Attachment A

Response to USEPA Comment No. 1d from letter dated December 3, 2019

As a follow-up to a conference call with United States Environmental Protection Agency (USEPA) Region 9 on December 20, 2019, Panoche Energy Center (PEC) has prepared the following response to Comment No. 1d from the letter provided by USEPA Region 9 dated December 3, 2019. As stated in PEC's e-mail dated December 20, 2019, PEC's planned response to Comment 1d would generally focus on the following four points:

Figure C-16 (New)

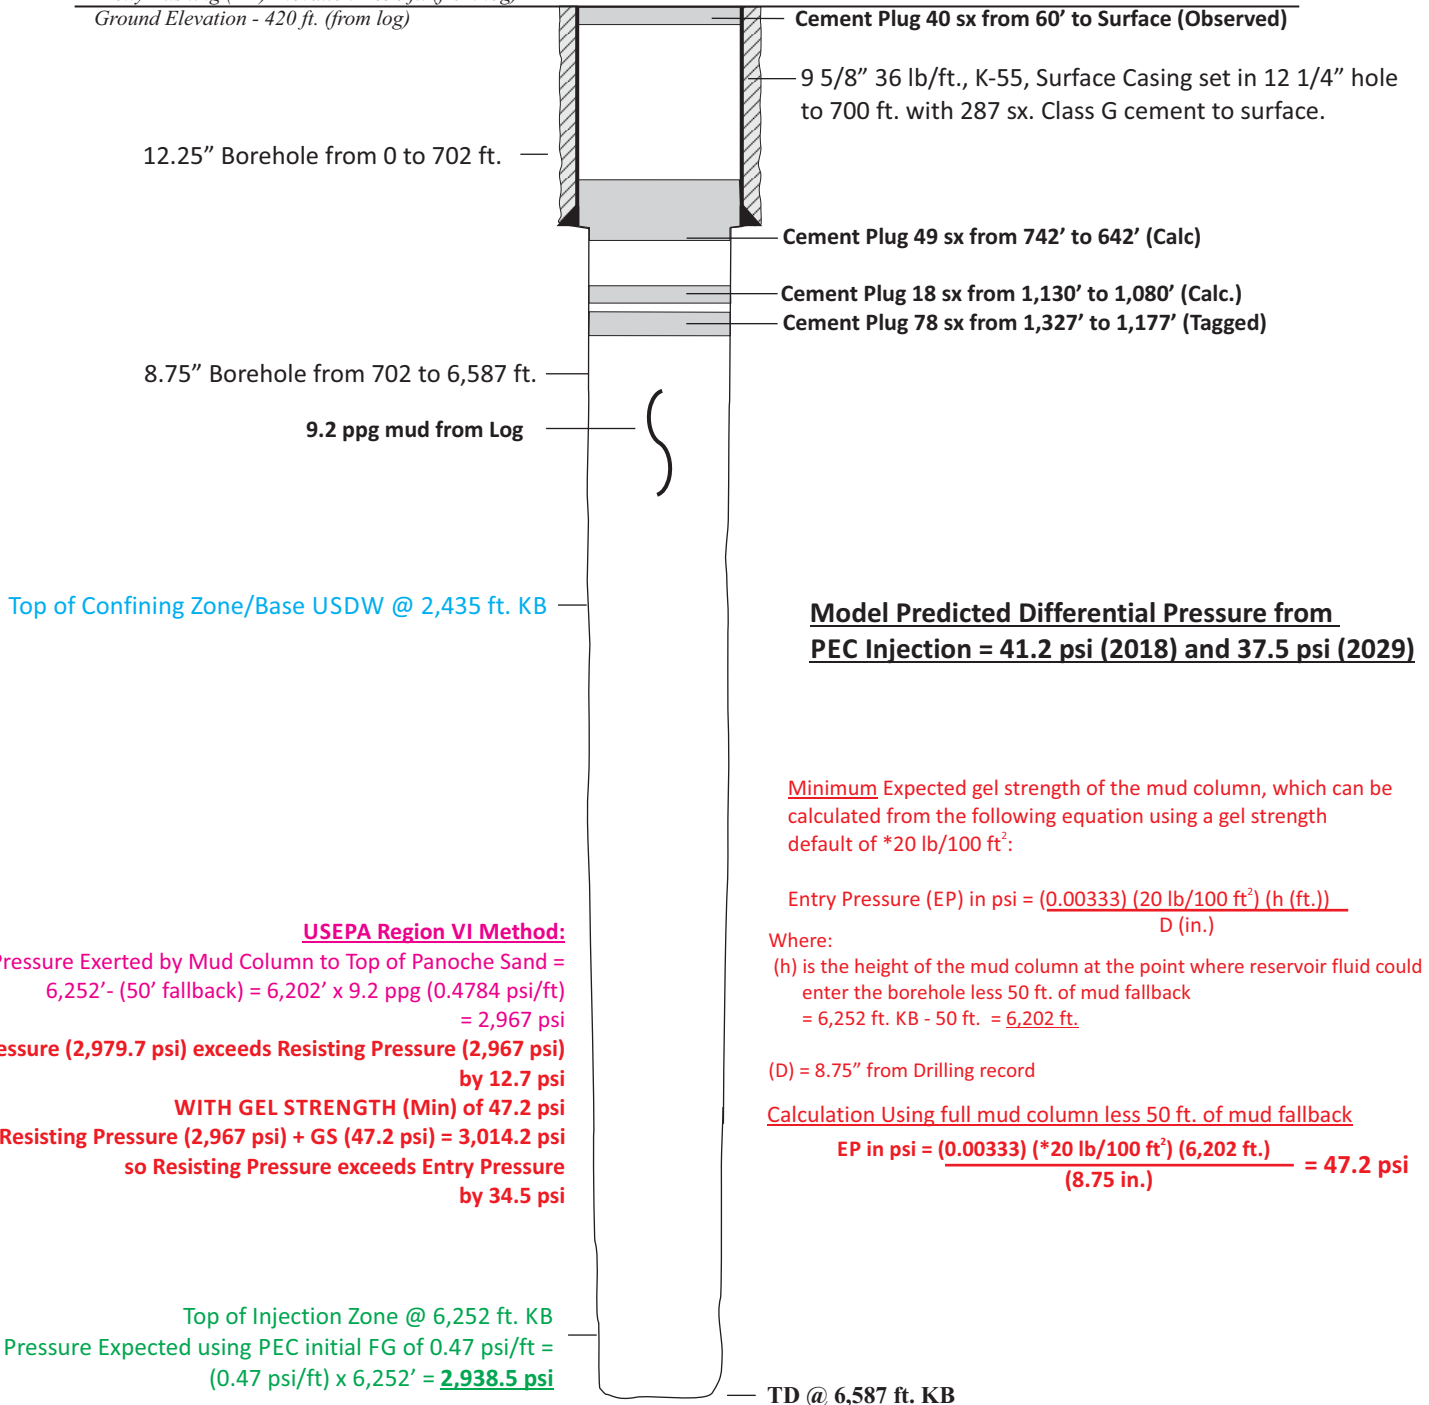
As shown in the well schematic in Attachment A-2 for Souza No. 2 (Figure No. C-16), this well was a dry hole drilled in 1985 to a depth of 6,587 feet below kelly busing level (KB). Surface casing was set to 700 feet KB and cemented to surface. No longstring casing was set in this well. Cement plugs were set in 1985 from 1,327 to 1,177 feet KB, 1,130 to 1,080 feet KB, 742 to 642 feet KB, and a surface plug from 60 feet KB to ground level. However, as mentioned above, no cement plug was set between the top of the injection zone and the base of the USDW (bottom depth of 2,435 KB), and relatively light drilling mud (9.2 pounds per gallon) was left in the borehole based on the open-hole log information. As discussed above in Section 2.2, if mud gel strength is included as part of the corrective action evaluation protocol, then the hydrostatic head of the fluid column at Souza No. 2 exceeds the calculated borehole entry pressure by at least 34.5 psi and this location passes the USEPA Region 6 protocol. However, if mud gel strength is removed as a consideration, then the mud column hydrostatic head is 13 psi less than the calculated borehole entry pressure at this location.

If corrective action at Souza No. 2 is needed, then we recommend an iterative approach where the mud sampling is attempted followed by plugging. This will address both Focus Points No. 2 and 3 listed above in Section 1.1. The general procedure for mud sampling and plugging would be as follows:

**Model Predicted Differential Pressure from
 PEC Injection = 41.2 psi (2018) and 37.5 psi (2029)**

$$\text{EP in psi} = \frac{(0.00333) (*20 \text{ lb}/100 \text{ ft}^2) (6,202 \text{ ft.})}{(8.75 \text{ in.})} = \mathbf{47.2 \text{ psi}}$$

Pressure Exerted by Mud Column to Top of Panoche Sand =
 6,252' - (50' fallback) = 6,202' x 9.2 ppg (0.4784 psi/ft)
 = 2,967 psi

Entry Pressure (2,979.7 psi) exceeds Resisting Pressure (2,967 psi) by 12.7 psi

WITH GEL STRENGTH (Min) of 47.2 psi
 Resisting Pressure (2,967 psi) + GS (47.2 psi) = 3,014.2 psi
 so Resisting Pressure exceeds Entry Pressure by 34.5 psi

SYNOPSIS: The model predicted pressure differential at this location is 41.2 psi at the end of 2018. This is a dry hole and no casing was set below the surface casing. There are no cement plugs between the base of the USDW and the top of the injection zone. Using the EPA Region VI method, the hydrostatic pressure provided by the mud column (2967 psi) is 13 psi less than the entry pressure (2,938.5 psi + 41.2 psi = 2,979.7 psi). However, the minimum drilling mud gel strength (using 20 lbs/100 ft²) provides an additional safety factor of 47.2 psi. Using the EPA Region VI method and the minimum calculated gel strength for the mud column from the surface (and assuming 50 ft. of mud fallback) to the top of the injection zone, the resisting pressure exceed the entry pressure by 34.5 psi. As such, using the EPA Region VI method and taking into account mud gel strength, this well is plugged in a manner that is protective of the USDW and no corrective action is necessary.
